Access Compliance Report Public Rights-of-Way (Curb Ramps)

Intersection ID: 10037058	Main Street: S TRYON ST	Cross Street: N/A	Location: SE
ADA ID: 5FC3F7E98EDD	Ramp Type: PerpDiag	Initial Pass/Fail: Fail	Overall Compliance: No Severity Score: 33.75

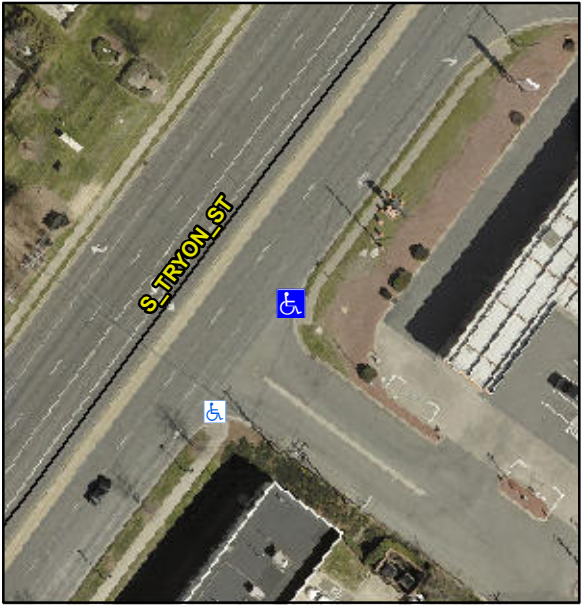
PROW/ADA:
Not Found, R304.5.1, R304.2.2, R304.5.3

Compliance	Description	Data	Compliance	Description	Data
N/A	Ramp Length (in)	57.0	No	Ramp Slope (%)	8.6
No	Ramp Width (in)	46.0	No	Ramp XSlope (%)	5.6
N/A	Flare Type LT	N/A	N/A	Flare Type RT	N/A
N/A	Flare Slope LT (%)	N/A	N/A	Flare Slope RT (%)	N/A
N/A	Flare Traversable LT?	N/A	N/A	Flare Traversable RT?	N/A
N/A	Landing Length (in)	N/A	N/A	DWS Provided?	N/A
N/A	Landing Width (in)	N/A	N/A	DWS Contrast?	N/A
N/A	Landing Slope (%)	N/A	N/A	DWS Length (in)	N/A
N/A	Landing X Slope (%)	N/A	N/A	DWS Full Width?	N/A
N/A	Landing Curb? (Y/N)	N/A	N/A	DWS Offset (in)	N/A
N/A	Shared Landing?	N/A			
N/A	Gutter Ponding?	N/A	N/A	Gutter Slope (%)	N/A
N/A	Gutter Lip Ht (in)	N/A	N/A	Gutter X Slope (%)	N/A
N/A	Painted X Walk1?	No	N/A	Painted X Walk2?	No
	X Walk 1 Direction	To N		X Walk 2 Direction	To S
N/A	X Walk 1 Width (in)	N/A	N/A	X Walk 2 Width (in)	N/A
	X Walk 1 Slope (%)	2.4		X Walk 2 Slope (%)	2.7
	X Walk 1 X Slope (%)	3.2		X Walk 2 X Slope (%)	1.6

Possible Solutions:
Remove & Replace Curb Ramp With Two New Directional Ramps or Equivalent.
